**BLOOMINGTON HISTORIC PRESERVATION COMMISSION**

**AMENDED AGENDA**

COA-17-01

COA-17-02

SHEET NO.  
**EA301**

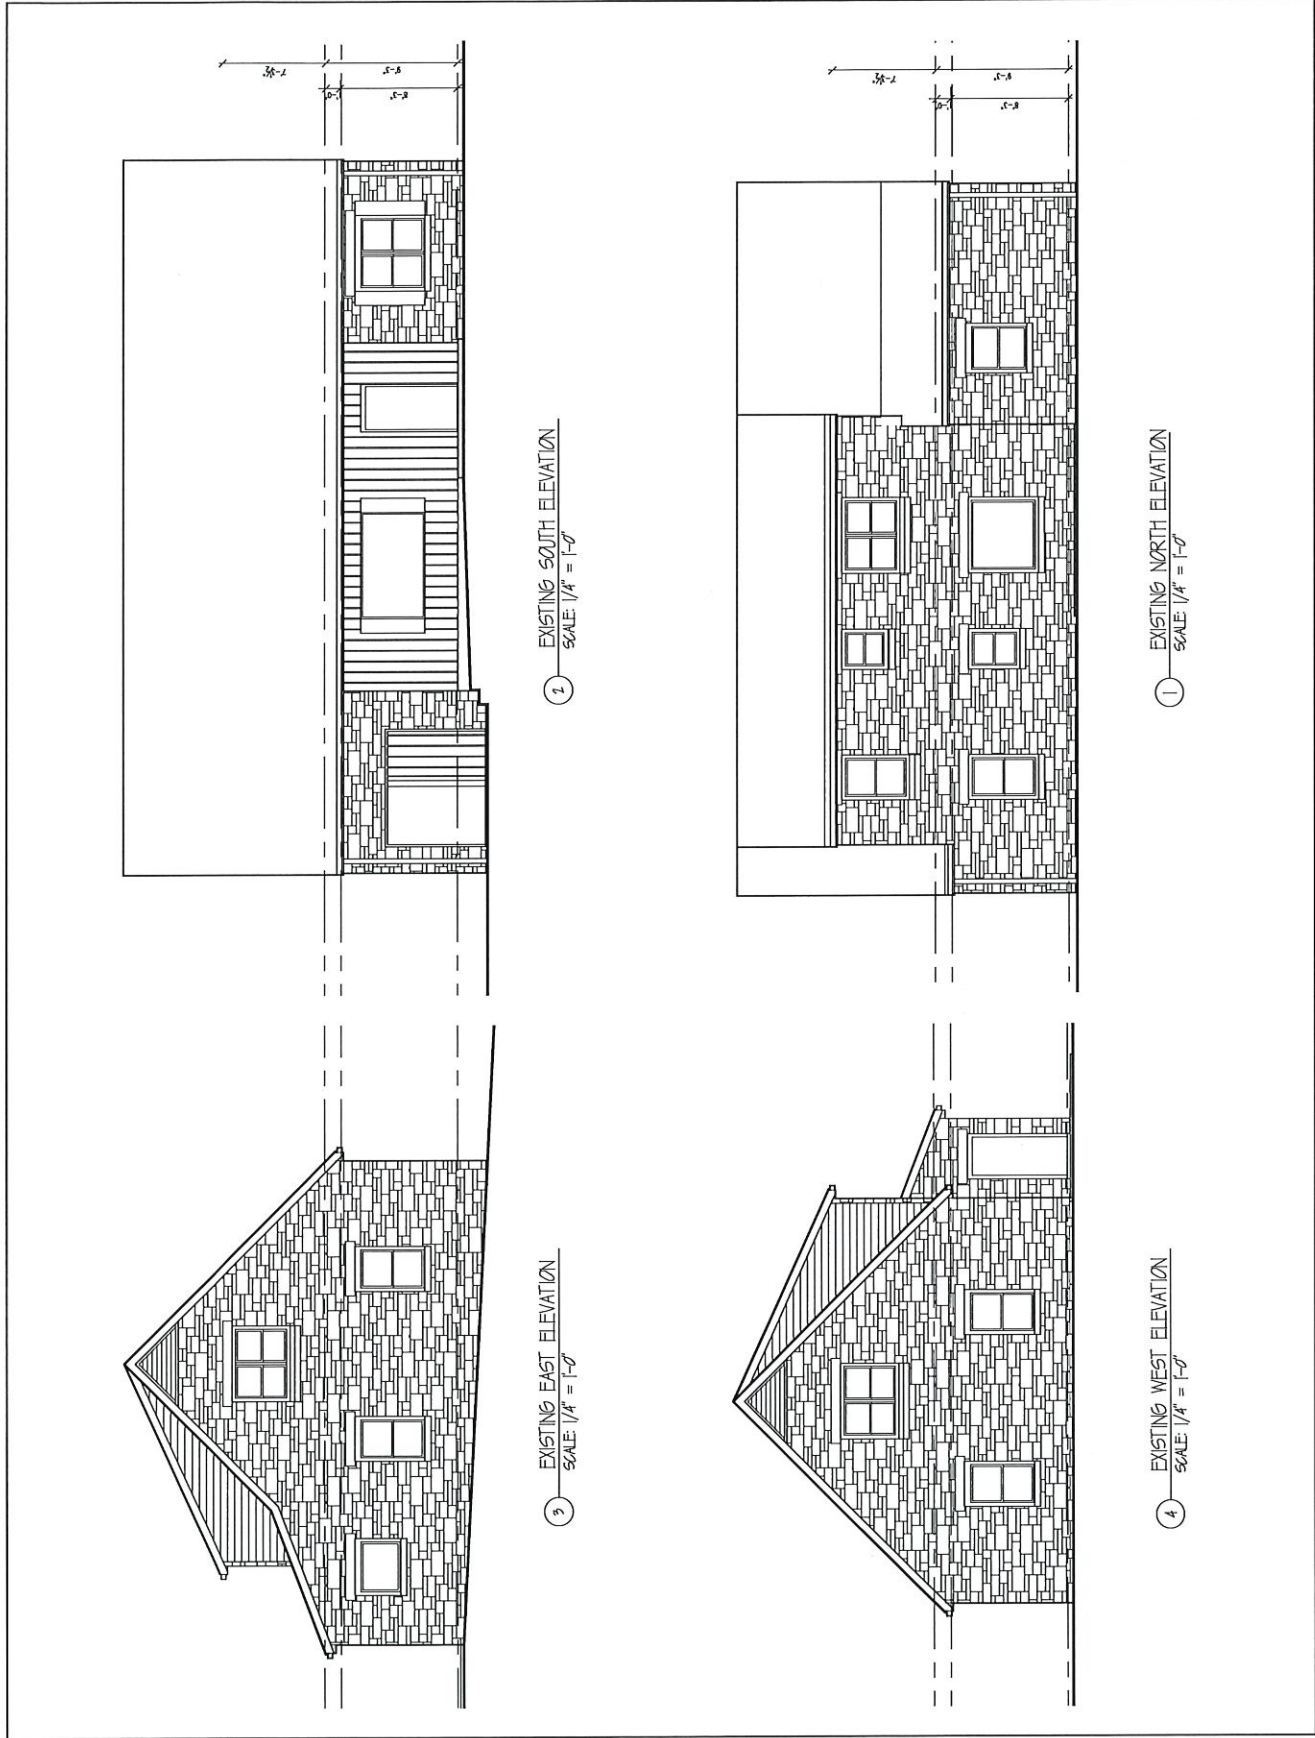
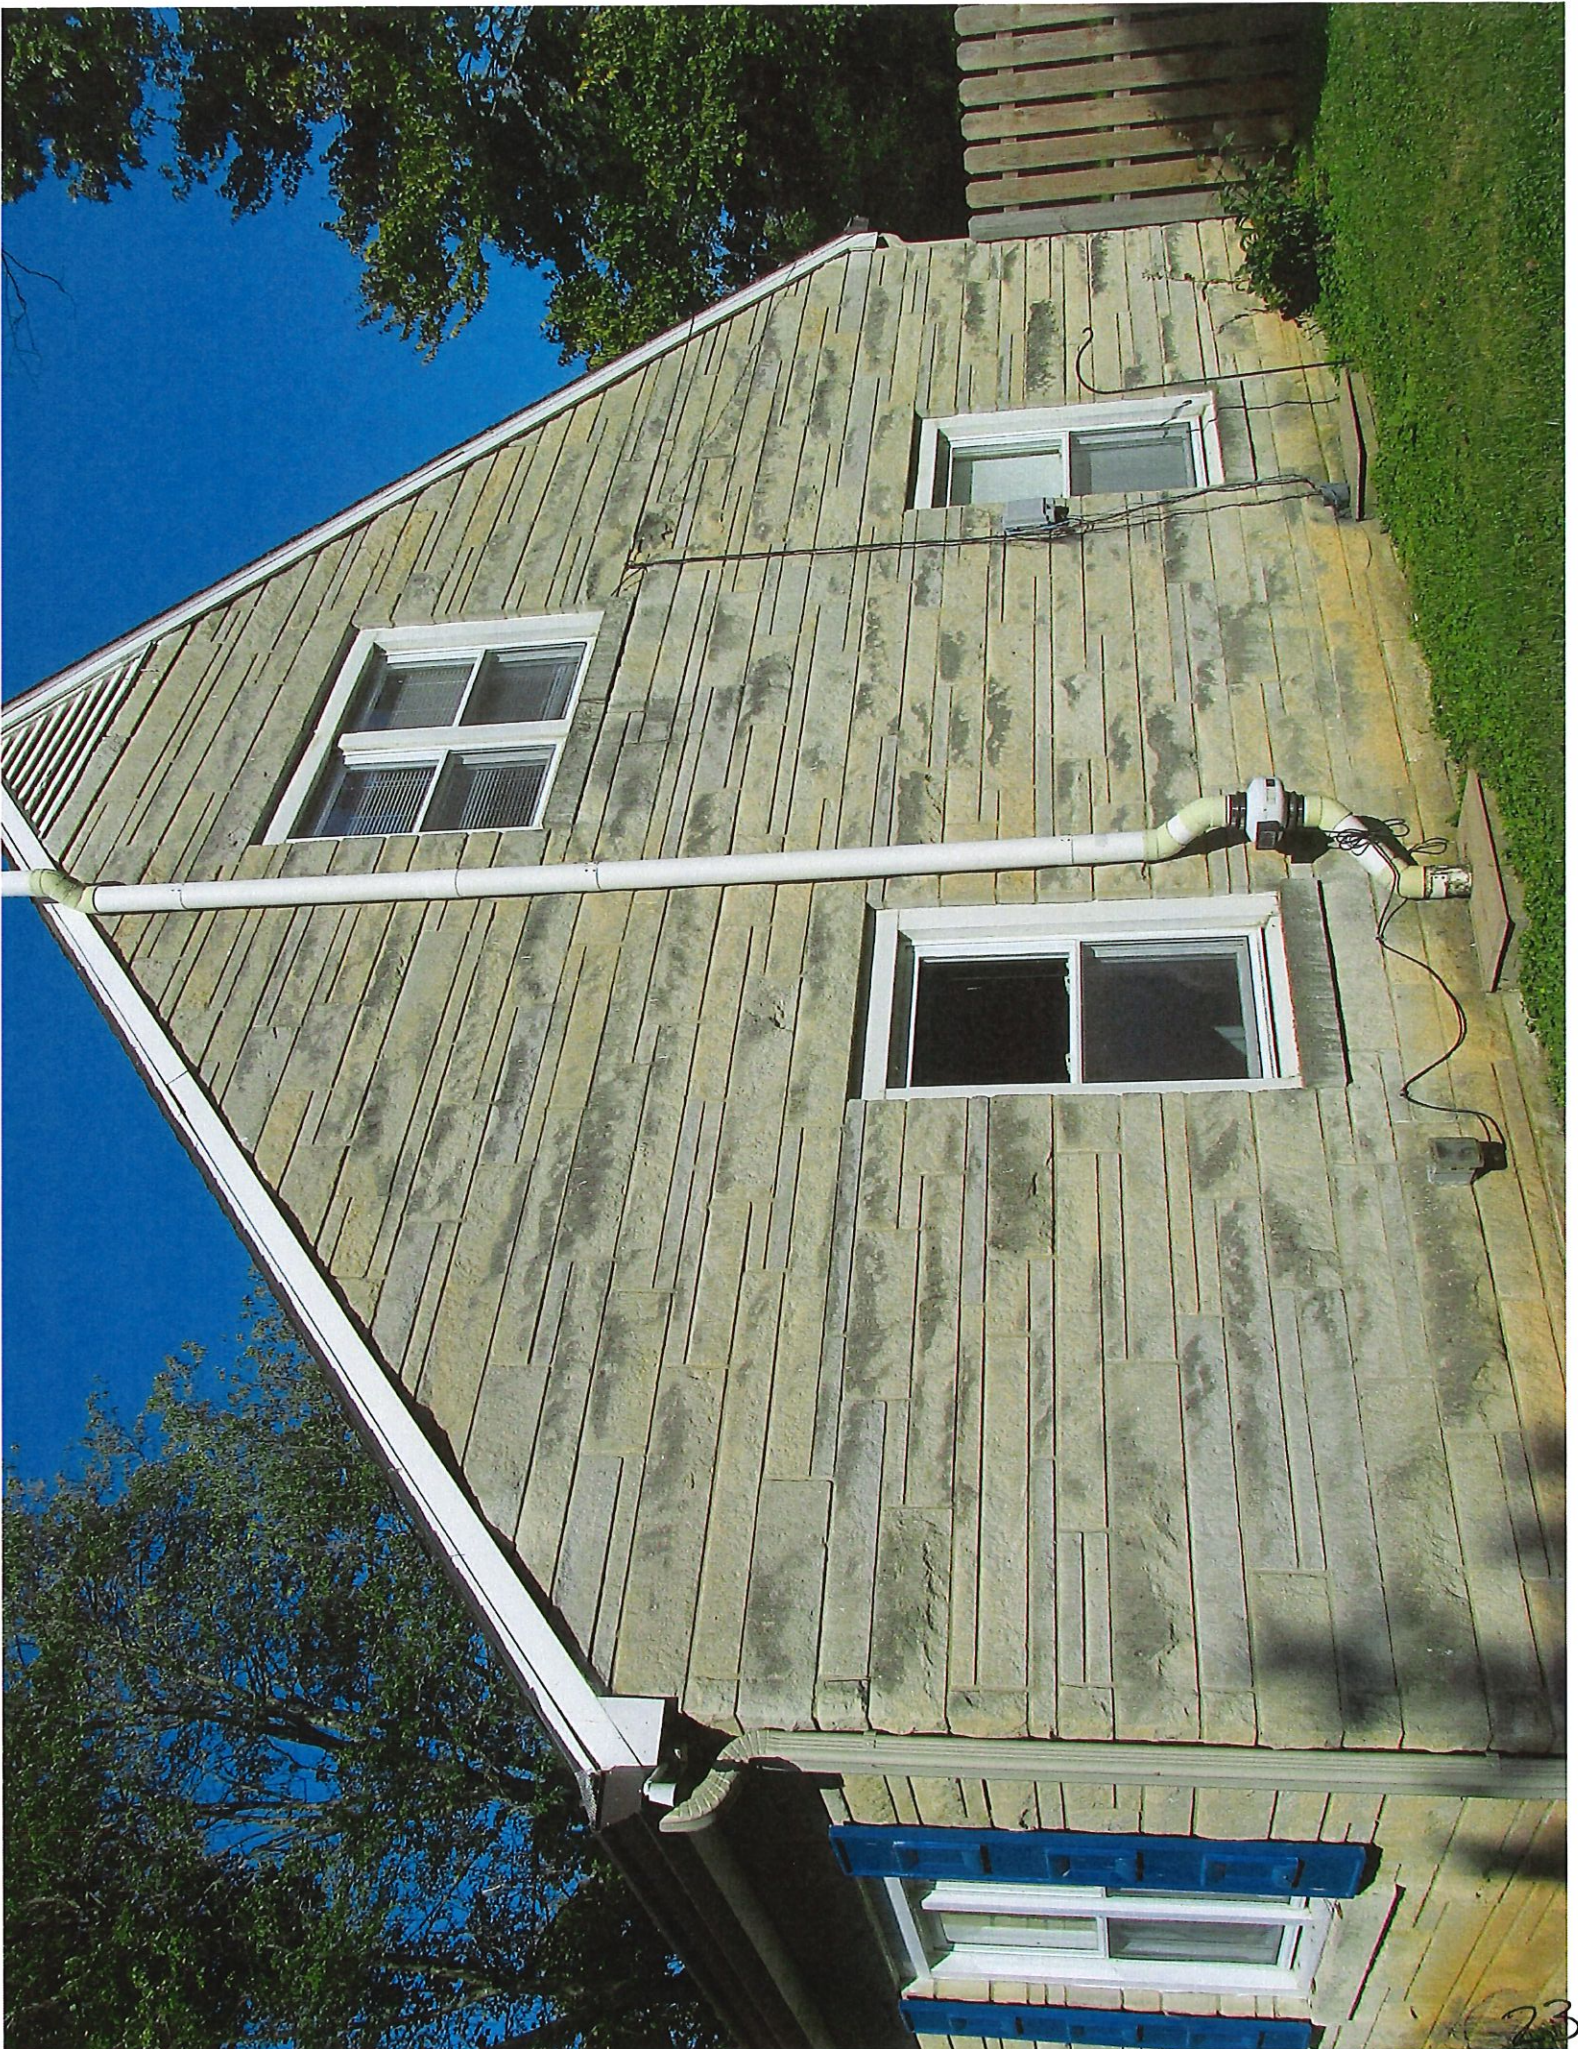
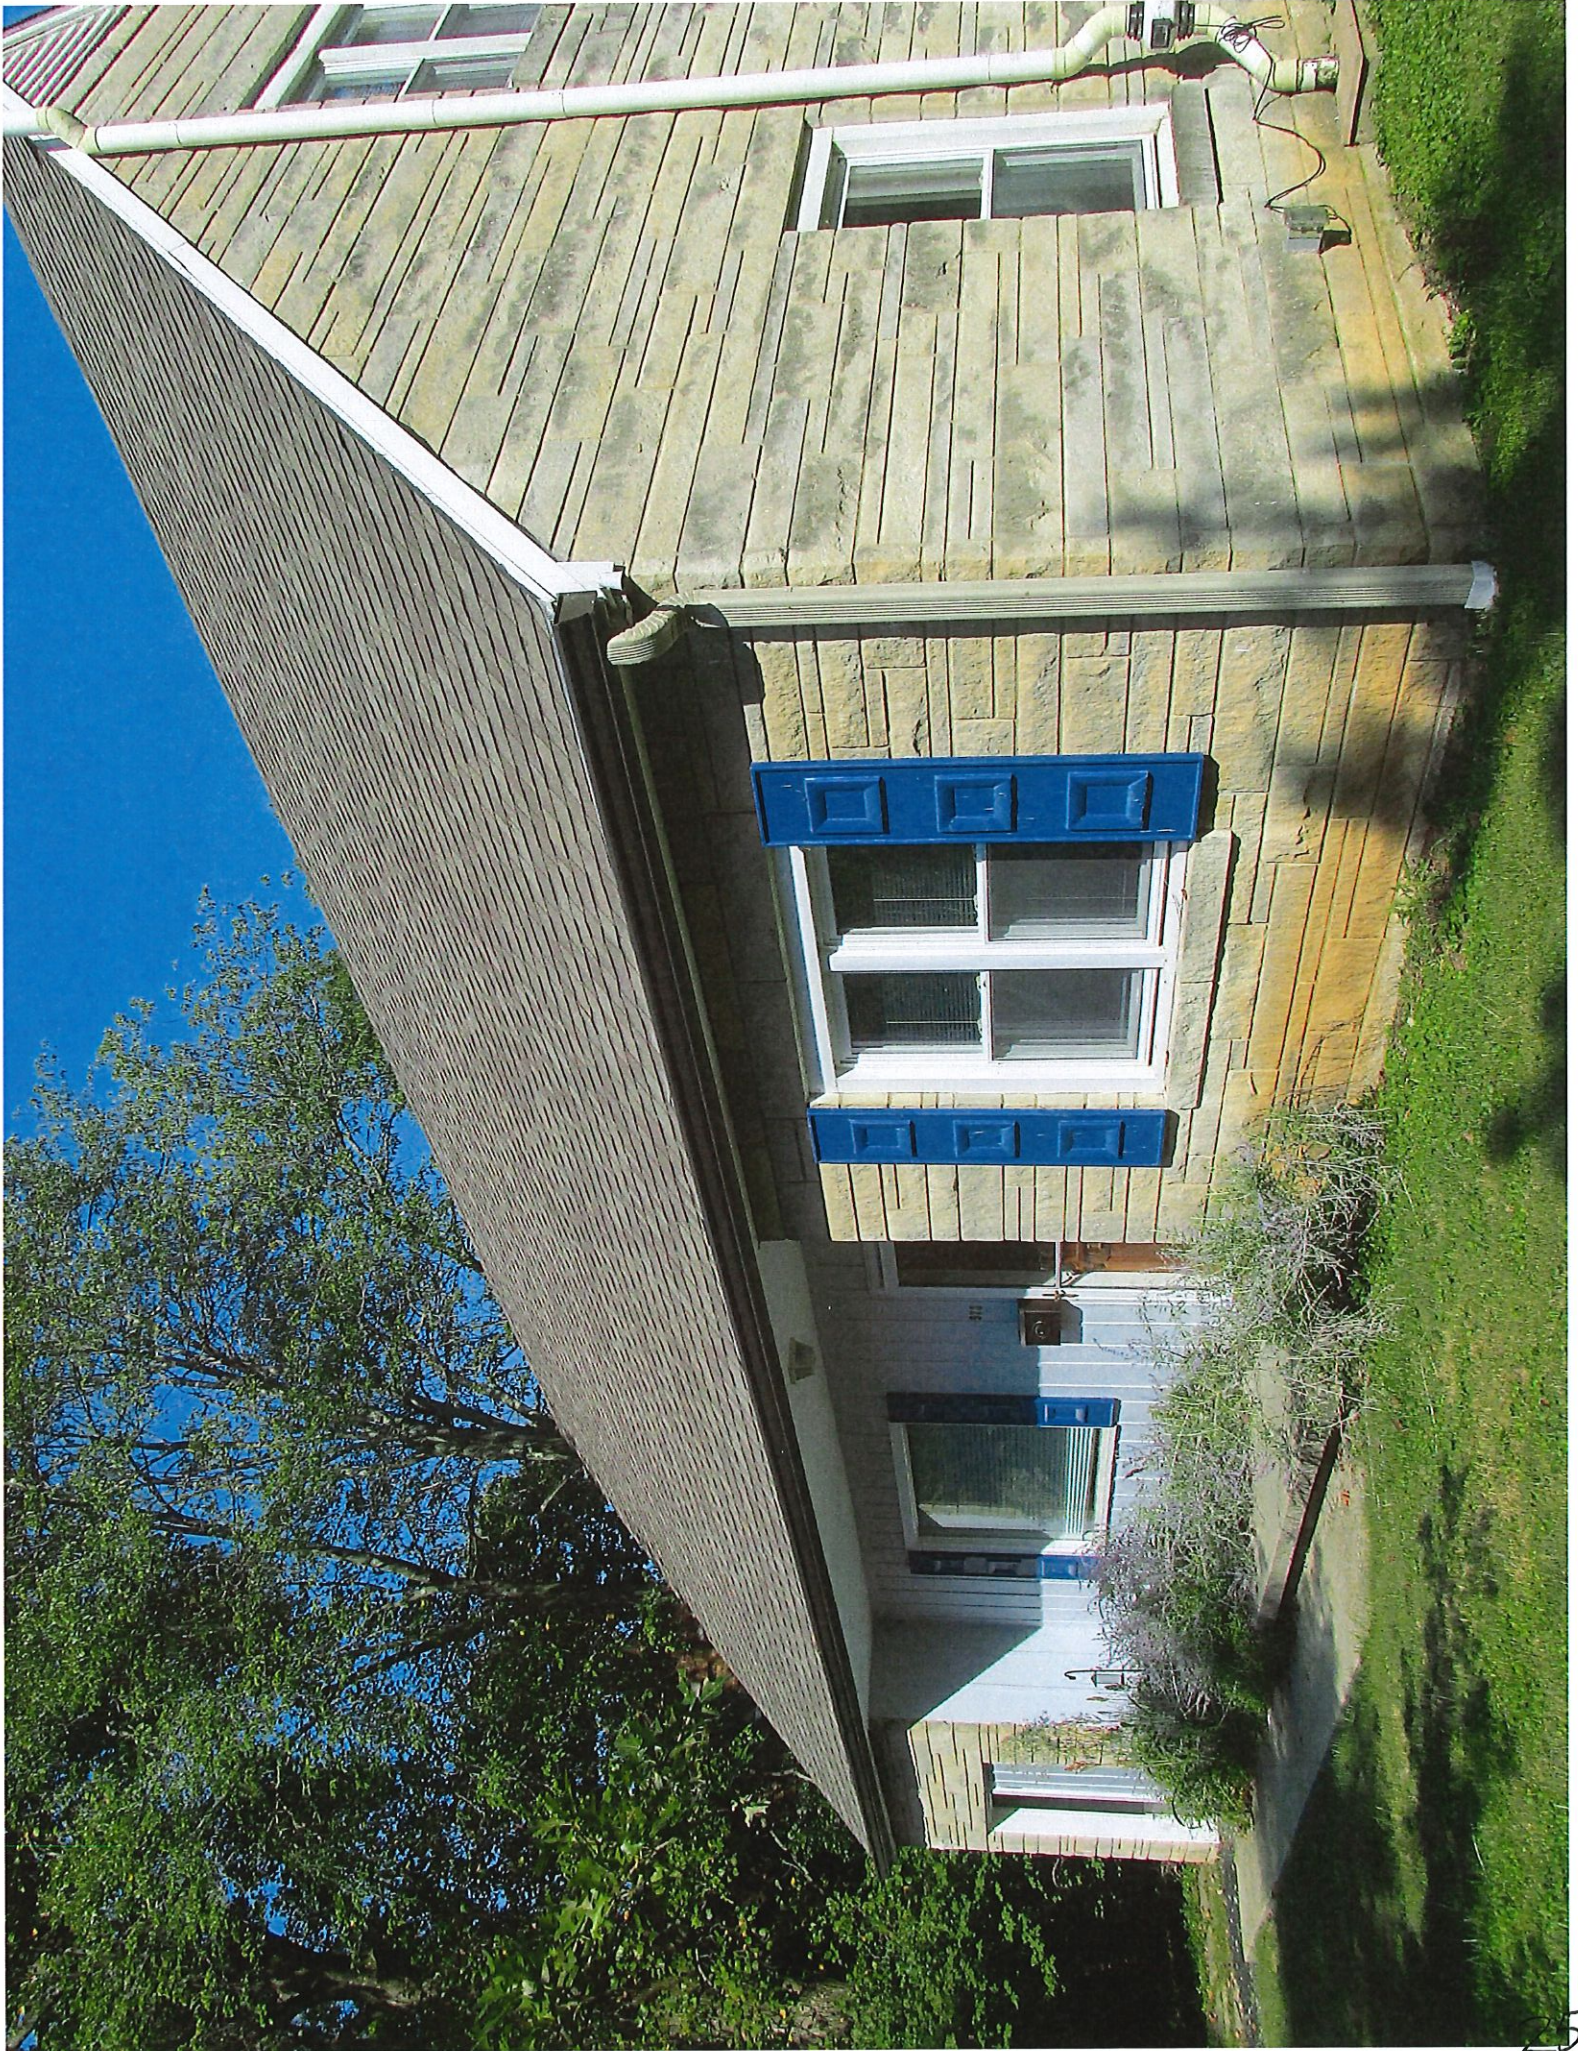
Per the Elm Heights design guidelines, the change to the garage in restoring the opening to a functional garage is appropriate. The picture window removal and installation of double-hung windows is a change “in the scale or proportion of existing openings,” which is an inappropriate treatment of windows to the primary façade per the Elm Heights design guidelines. The front door, as shown in the drawing, is not consistent with the style of this house. Per the Elm Heights design guidelines and the Secretary of Interior Standards, the second story addition is not a recommended treatment and will diminish the historic character of this style of house.

This property just came onto the survey as contributing in the 2015 survey as a c.1950, ranch. Although it doesn't fit the Elm Heights period of significance, it is a good example of the continuing timeline of the neighborhood and of a 1950s ranch style house. The proposed changes will so significantly alter the character that it will no longer be contributing. Staff is supportive of the garage door. The front door is already a replacement, but the drawings show a front door that would not follow the characteristics of the house. Staff is not supportive of the second story Chalet style addition. Something more appropriate to the era would be Cape Cod windows to give a more Minimal Traditional feel, rather than try and imitate another era.

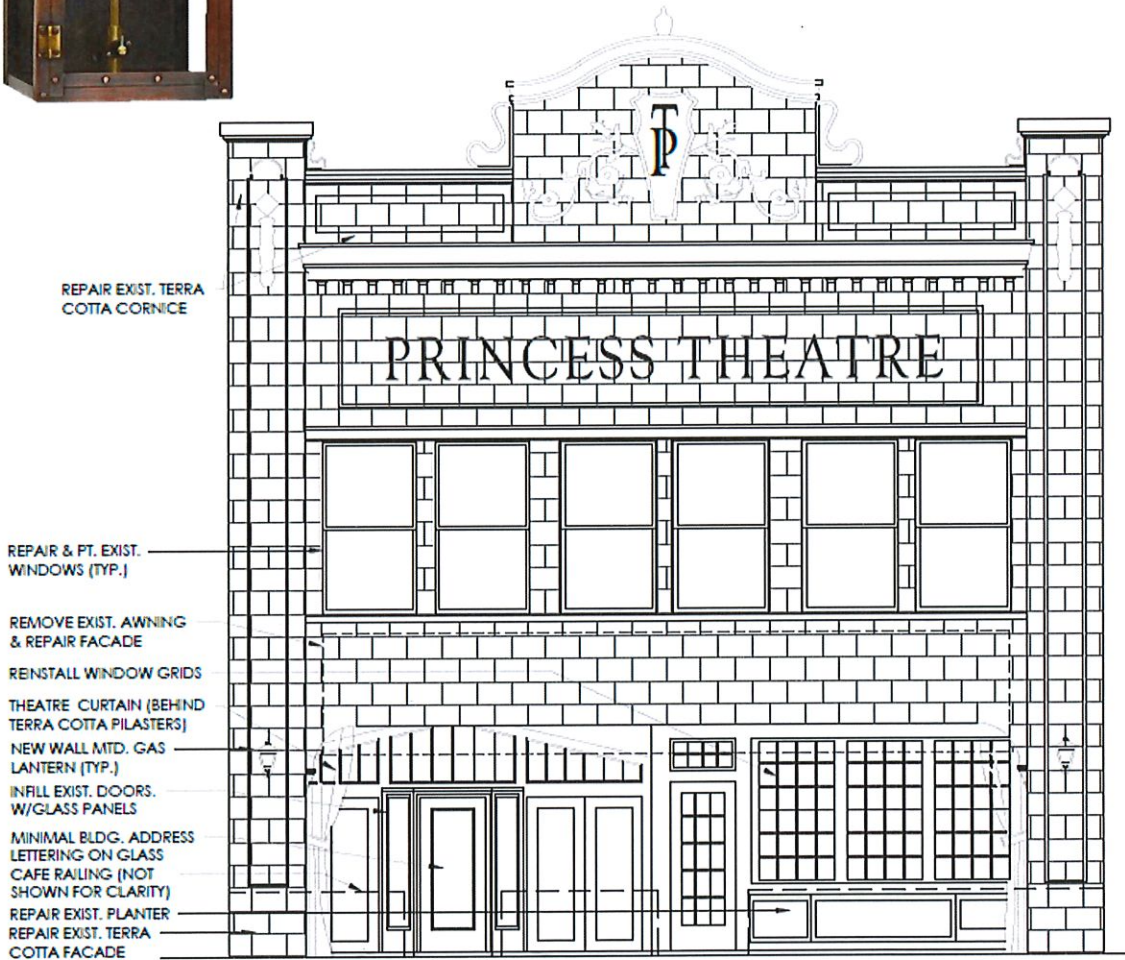
The photo on the left shows the theater without the awning and with the window grids. The petitioner is looking to repair and restore much of the terra cotta and the 1920s era

Staff is supportive of the restoration of the front façade by removing the awning and returning the grids to the windows. The box office form will remain and the doors have been altered and therefore staff is supportive of the installation of an ADA accessible entrance from the front of the box office. Staff is concerned with the installation of the wall mounted lanterns as it could damage the glazed terra cotta. If they were mounted only into the mortar joint, it would be preferred. Staff is supportive of the installation of theater curtains behind the terra cotta pilasters. The café railing is free-standing and ground mounted and therefore will not interfere with the historic fabric. Staff is supportive of the railing.
